# Development Management Sub Committee

**Application for Listed Building Consent 19/02624/LBC  
At 1 Grant Avenue, Edinburgh, EH13 0DS  
Application for removal of single glazed metal and timber  
windows and replacement with new double glazed  
hardwood timber windows. (In retrospect)**

1.1 It is recommended that this application be Refused for the reasons below.

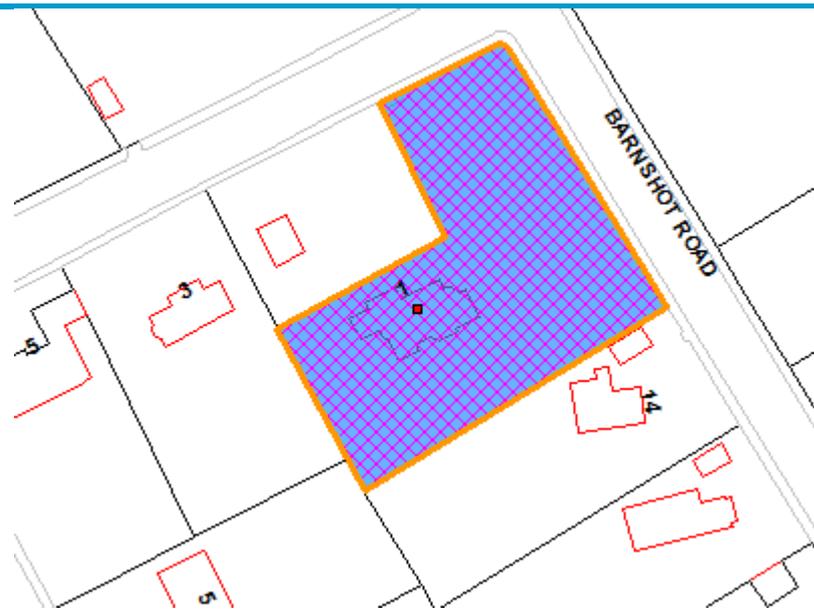
*However, despite this lack of information, it appears the new hardwood timber windows do not replicate the original metal window designs accurately or successfully. They are of a different material, section and design.*

*The original metal windows had slender sections, contained within timber framing. The casement windows appear much thicker in section with a reduction in emphasis on the framing elements around them.*

*We would be happy to comment further when and if more details become available, but with the information to hand we would suggest the replacement windows are a poor match for the original patterns, and have a significantly adverse effect on the character of the building. With the loss of the original windows, in order to protect the special interest of the listed building, we would recommend more accurate replacement windows are investigated instead.*
